TO: Casey Adragna, Adragna Architecture
FROM: Amber Wood Hicken, Planner I
DATE: 5/5/25
SUBJECT: Douglas 234 Multitenant, Site Plan
Review Comments 01

HORSE CREEK COMMERCIAL

Description: **Douglas 234 F6 AMD 2 L10B - Commercial Building**

SITE PLAN
DOUGLAS 234 FILING NO. 6, AMD. 2
JOB NO. 24020
DATE: FEBRUARY 12, 2025
SHEET C3

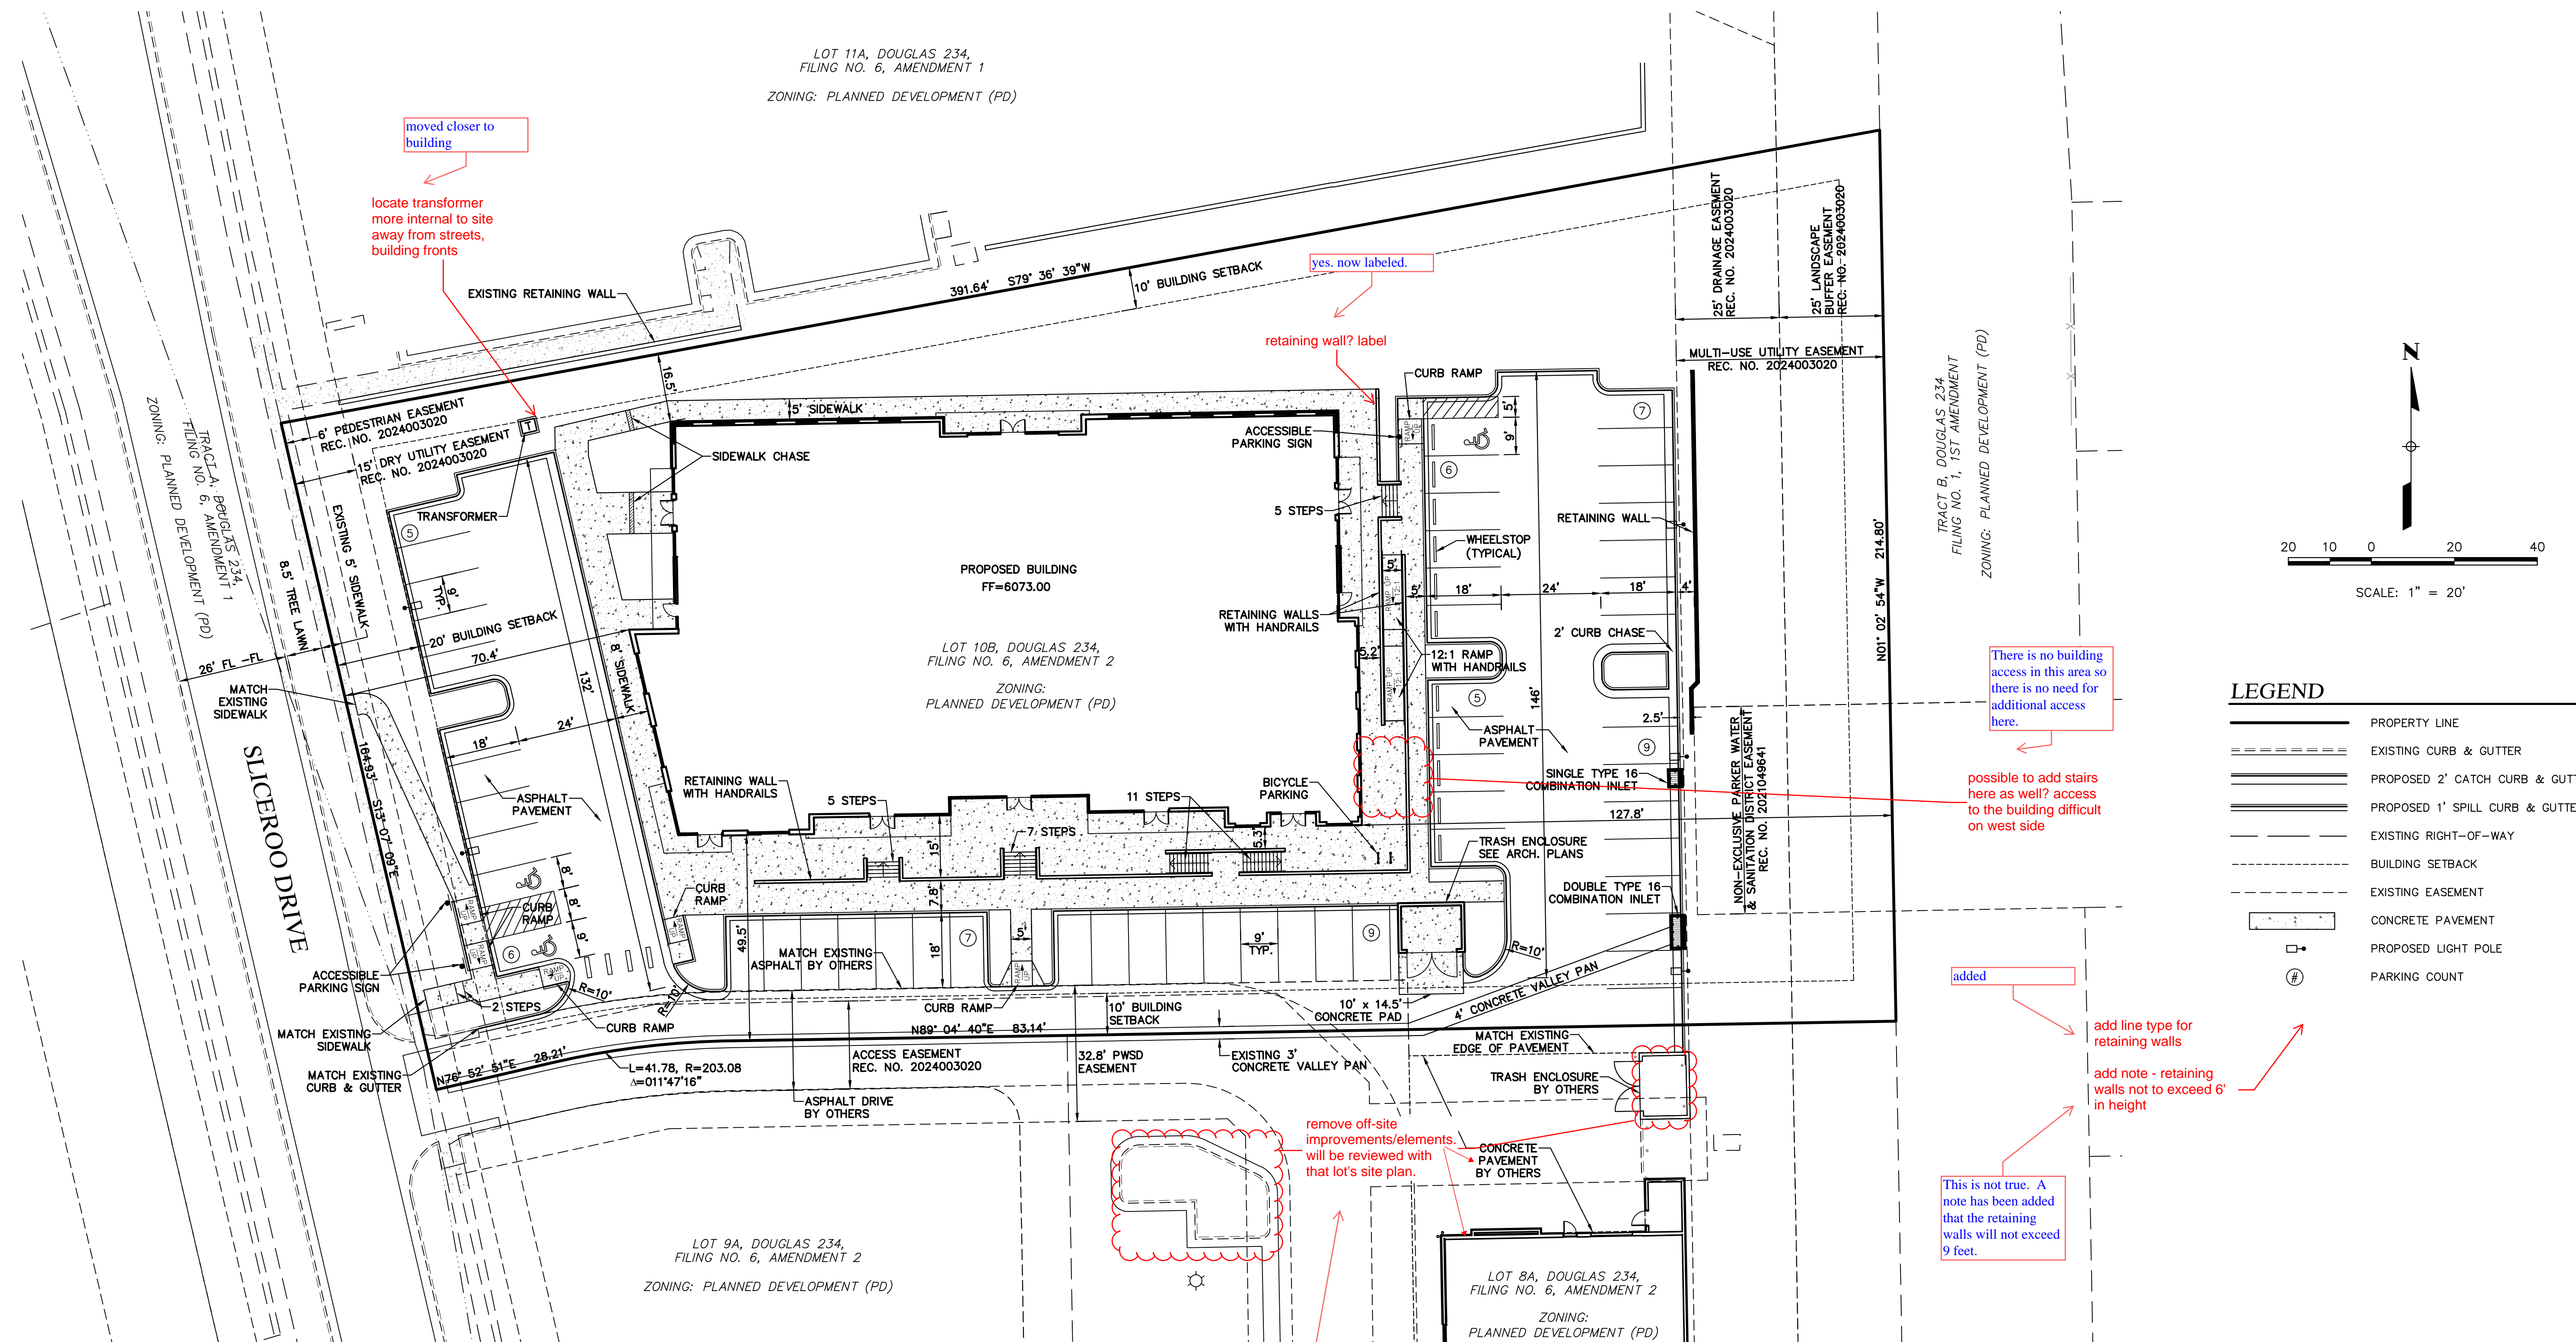
locate transformer more internal to site away from streets, building fronts

retaining wall? label

possible to add stairs here as well? access to the building difficult on west side

add line type for retaining walls
add note - retaining walls not to exceed 6' in height

remove off-site improvements/elements will be reviewed with that lot's site plan.

moved closer to building

yes, now labeled.

There is no building access in this area so there is no need for additional access here.

added

This is not true. A note has been added that the retaining walls will not exceed 9 feet.

removed

PLANT REQUIREMENTS

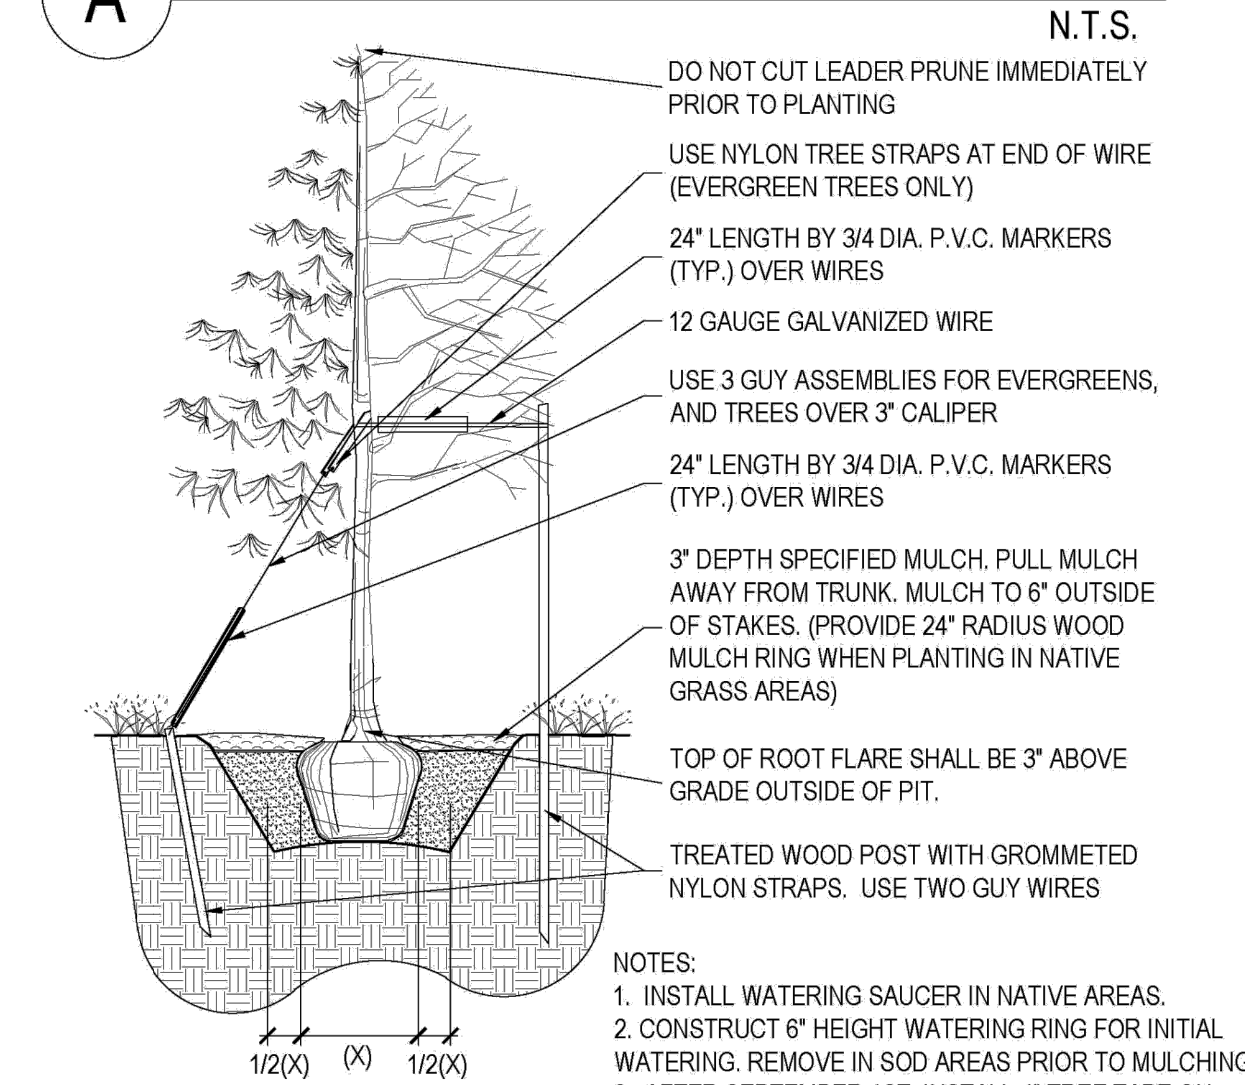
show 75% required (% and sq footage)

grasses may substitute for shrubs (One ornamental grass in a five-gallon container or three ornamental grasses in one-gallon containers may be substituted for one shrub)

perimeter landscaping applies to all sides except south. show buffer widths, tree/shrub count

north - P1
east - P3 (fence, evergreen requirements)
west - P2 (parking lot adjacent to ROW)

parking lot interior landscape table needed. break out LS islands, show square footage and tree/shrub requirements. 10% of parking lot must be landscaped.

calculations based off amount of LS provided.
19 trees, 95 shrubs
CALCULATIONS UPDATED.

calculation based off living material (7,704)

1155sf max

A TOTAL LANDSCAPE REQUIREMENTS TABLE HAS BEEN ADDED.

CALCULATIONS UPDATED.

THE ADDITIONAL PERIMETER AREAS HAVE BEEN ADDED TO THE TABLE.

PARKING LOT TABLE ADDED.

REVISED. cover sheet shows 23,768sf of landscaping

plant schedule shows 36 trees, 89 shrubs
CALCULATIONS UPDATED.

CALCULATIONS UPDATED.

SITE PHOTOMETRIC PLAN
 DOUGAS 234 FILING NO. 6, AMD. 2
 DATE: FEBRUARY 17, 2025
 SHEET LT1

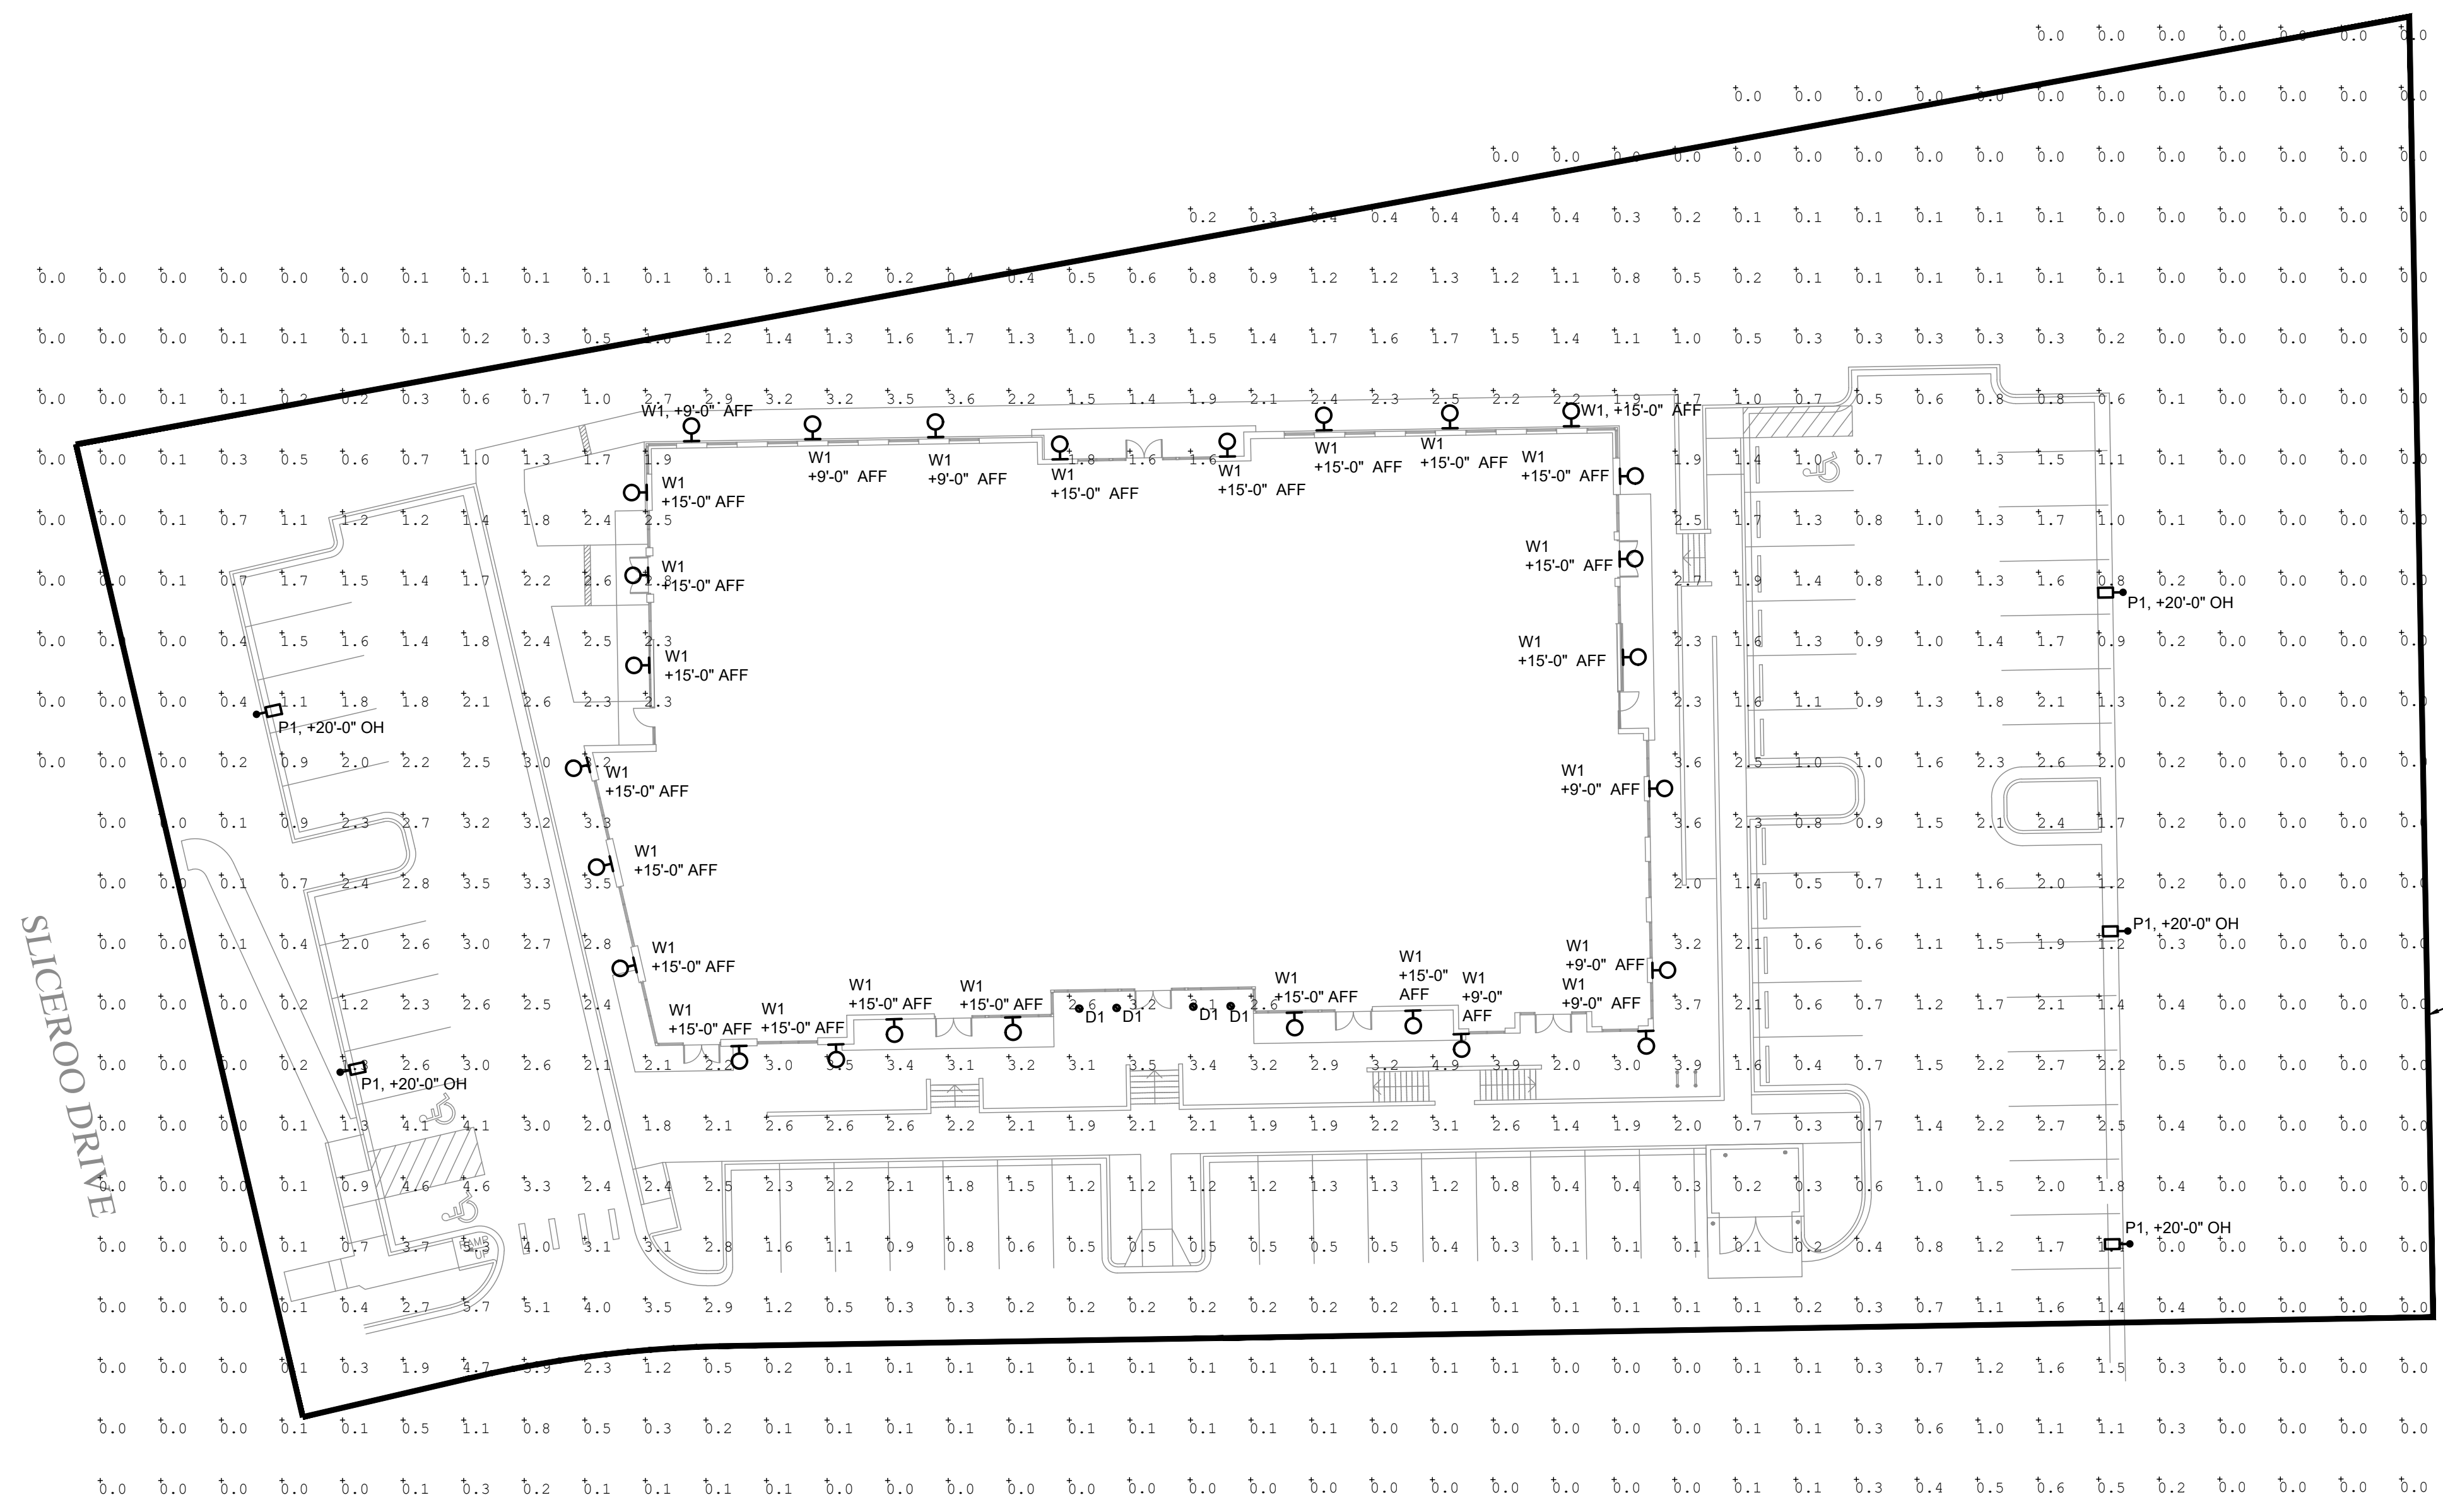
add heights of
mounts/poles

add pole color

All freestanding light fixtures shall be set back from each property line a distance at least equal to the total height of the luminaire.

provide setbacks from poles to property lines

These have been added.

We have now shown pole heights and setbacks from property line.
